Model: Model C-C1		Date: 13-Apr-04	No.: RB173001
Subject: Service Manual Correction		Prepared by: A. Ishiyama	
From: 1st Technical Support sec. Service Support Dept.			
Classification:	<input type="checkbox"/> Troubleshooting <input type="checkbox"/> Mechanical <input type="checkbox"/> Paper path <input type="checkbox"/> Other ()	<input type="checkbox"/> Part information <input type="checkbox"/> Electrical <input type="checkbox"/> Transmit/receive	<input type="checkbox"/> Action required <input checked="" type="checkbox"/> Service manual revision <input type="checkbox"/> Retrofit information

Please apply the following revisions to your Service Manuals. This bulletin contains the revised pages only, which has been posted to the RISSN server along with a separate full-manual version.

Model: Model C-C1		Date: 2-Jul-04	No.: RB173002
Subject: Machine Firmware History		Prepared by: A. Ishiyama	
From: 1st Technical Support Sec. Service Support Dept.			
Classification:	<input type="checkbox"/> Troubleshooting <input type="checkbox"/> Mechanical <input type="checkbox"/> Paper path <input type="checkbox"/> Other ()	<input type="checkbox"/> Part information <input type="checkbox"/> Electric

2. PREVENTIVE MAINTENANCE

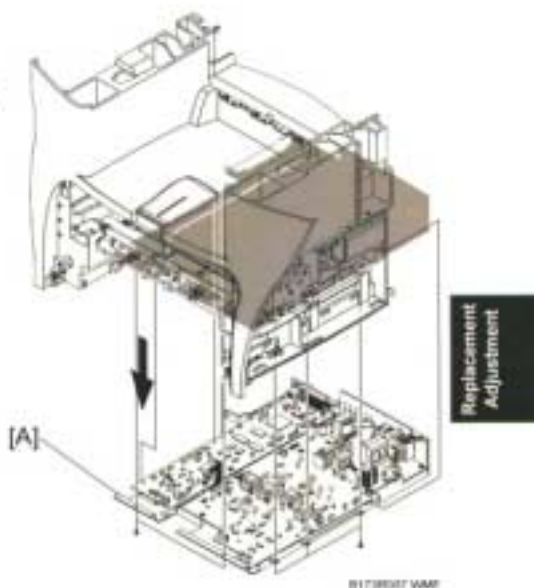
Section	Page	Correction
TABLE OF CONTENTS	iv	Some section numbers and page numbers have been corrected.
2. PREVENTIVE MAINTENANCE	2-1	The PM table has been corrected.

Component	Replacement Cycle	Done by
Scanner	ADF Rubber	20,000 Pages	Service
	ADF Pick-up Ass'y	60,000 Pages	Service
Printer	Friction Pad	60,000 pages	Service
	Paper Feed Roller	60,000 Pages	Service
	Transfer Roller	60,000 Pages	Service
	Fuser	60,000 Pages	Service

3.10 MAIN PBA (MAIN BOARD)

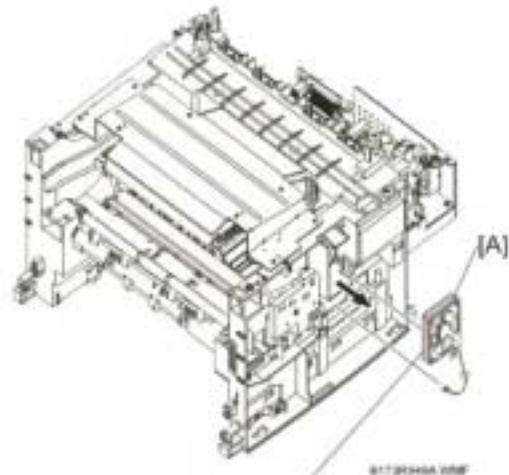
3. REPLACEMENT AND ADJUSTMENT	3-17	3.10 MAIN PBA (MAIN BOARD): A note has been added.
	3-20	3.13 FAN: A procedure has been corrected. A caution has been added.

NOTE: 1) Print out the system data list in Tech mode to keep programmed data before you do the replacement procedure.
2) Do the "Clear All Memory" in Tech mode (➡ 5.2.3) after you finish the replacement procedure.
